WASHINGTON STATE
DEPARTMENT OF TRANSPORTATION
CHANGE ORDER

CONTRACT NO: XE3476 FEDERAL AID NO: 0167(059)
CONTRACT TITLE: SR 167, SR 161 TO SR 410 REBUILD INTERCHANGE
CHANGE ORDER NO: 3 UNSUITABLE MATERIAL

CHANGE ORDER NO: 3

MAINLINE TYPICAL SECTION

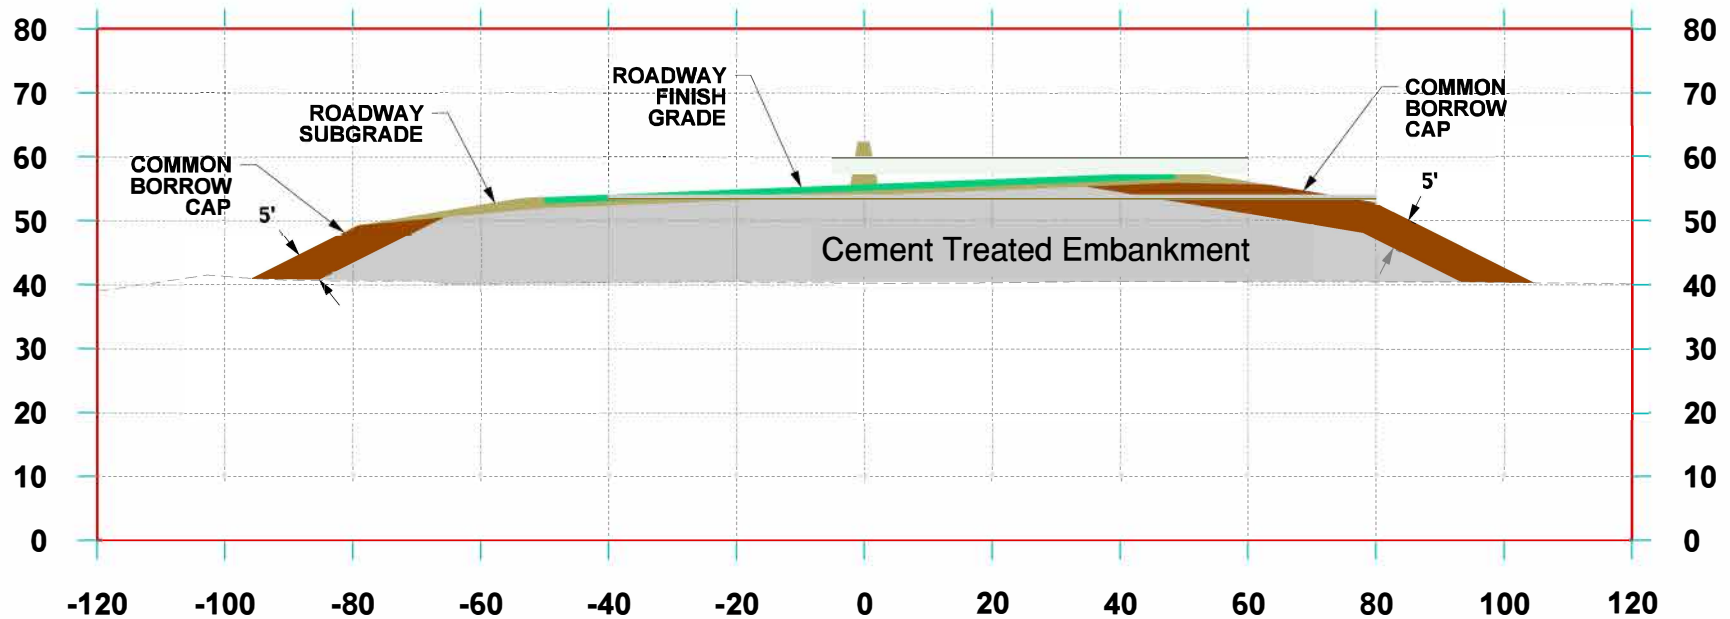
The soil cement treatment material shall be placed outside Bridge Approach Embankments, unless approved by the WSDOT Engineer. The cement treated embankment may be constructed to the proposed subgrade elevation and may extend to within 5 feet of side slopes as shown in the cross-section on page 5 of this Change Order. The slopes of the cement treated embankment shall be shaped to a stepped pattern to allow interlocking of cement treated embankment and clean Common Borrow capping material.
